STAFF REPORT
COMMUNITY DEVELOPMENT DEPARTMENT

HEARING DATE: 3/26/2024
TO: Mayor & City Council
FROM: Stacy Hersh, Associate Planner
208-884-5533
SUBJECT: Foxcroft No. 2 FP
FP-2023-0031
LOCATION: Phase 2 is located at 3500 W. Pine Avenue and the surrounding property north of Pine and south of Tenmile Creek, in the SE 1/4 of the NE 1/4 of Section 10, Township 3N, Range 1W.

Final Plat consisting of 1 residential building lot on approximately 11.978 acres of land in the R-15 zoning district, by Kent Brown Planning.

B. Final Plat

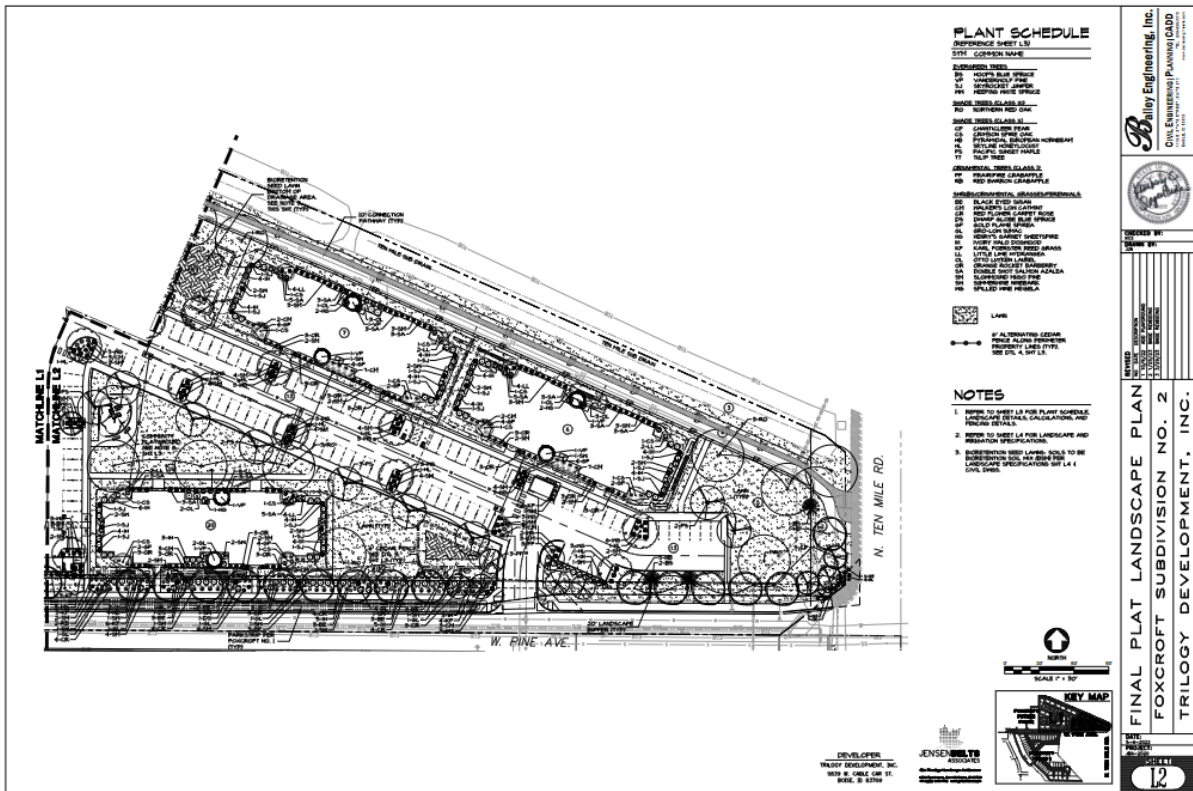
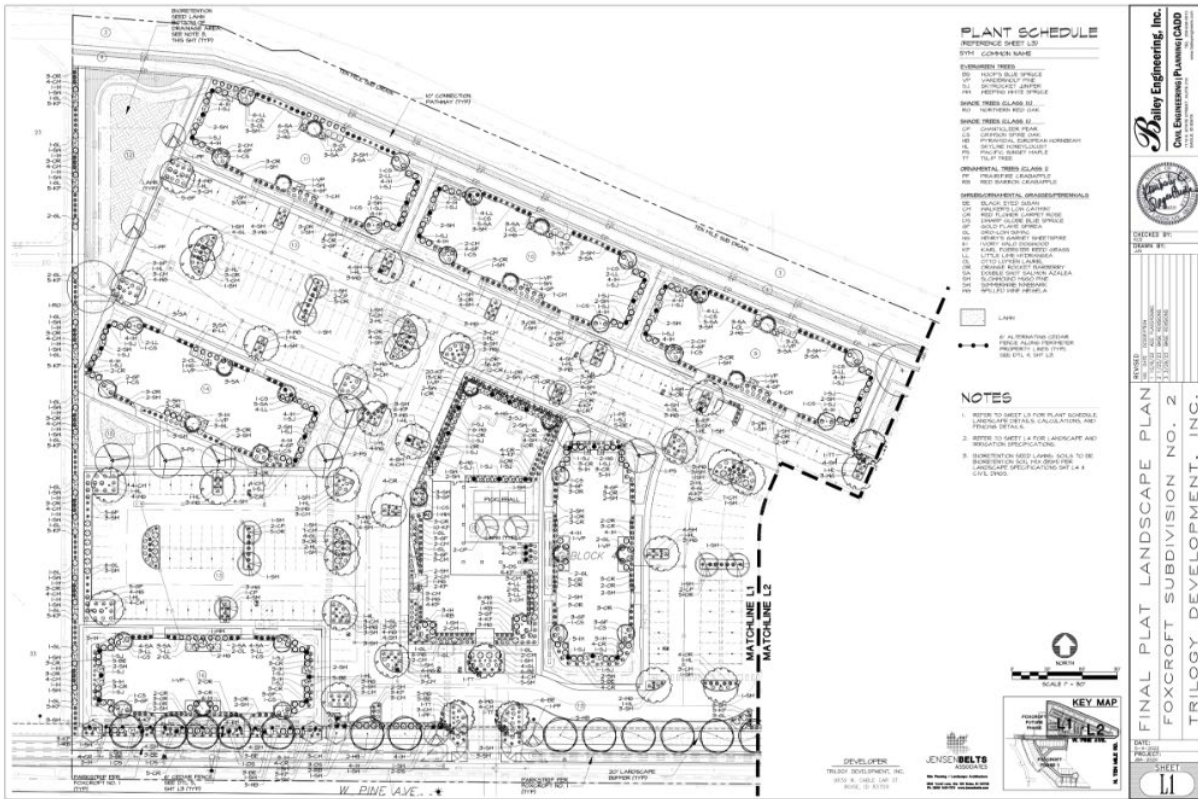
- a. Plat Note #8, include recorded instrument number.
 - b. Plat Notes #12-13, include recorded instrument numbers.
 - c. Add Note #13, include the recorded instrument number of the existing City of Meridian Development Agreement.

- d. Add Note #14, include the recorded pathway easement number (ESMT-2024-0043) on the plat.
 - e. Graphically depict the landscape buffers along the east and south boundary either on a permanent dedicated buffer easement or by adding common lots in accordance with UDC 11-3B-7C.2a
